WATER QUALITY MEMORANDUM

Utah Coal Regulatory Program

RE: 2008 First Quarter Water Monitoring, PacifiCorp, Trail Mountain Mine,
C/015/0009, Recurring Task ID #2713

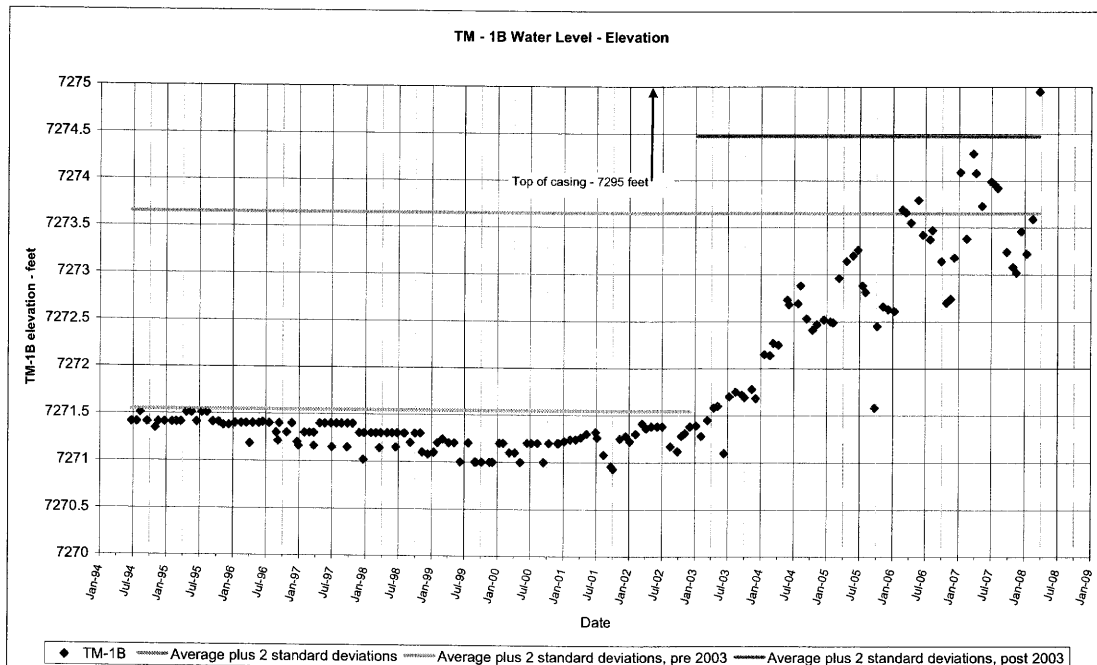
TM-1B March: depth and carbonate as CaCO_3 . The head in TM-1B has been slowly rising since early 2003. The cause is not evident. See the chart below.

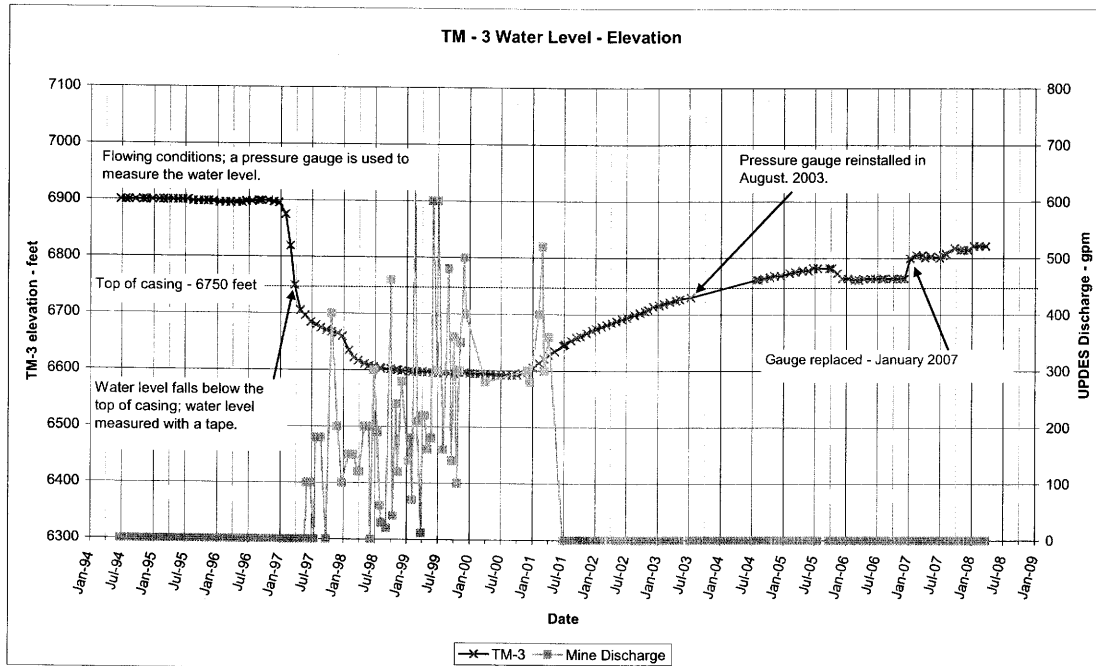
TM-3: water elevation peaked in June 2005, remained steady through October, dropped 18.5 ft in November and December 2005 and remained virtually unchanged during 2006. The pressure gauge was replaced in January 2007 and values jumped to approximately match the pre-2006 curve. During the first half of 2007, the curve was relatively flat, but it resumed climbing during the third quarter. Pressure was flat during the 4th quarter 2007: the Permittee should check the accuracy of the pressure gauge. See the chart below.

Pressure at TM-3 changed from the 4th quarter 2007 to the 1st quarter 2008, but the pressure remained unchanged within each quarter, which may indicate the gauge is not actually being checked monthly.
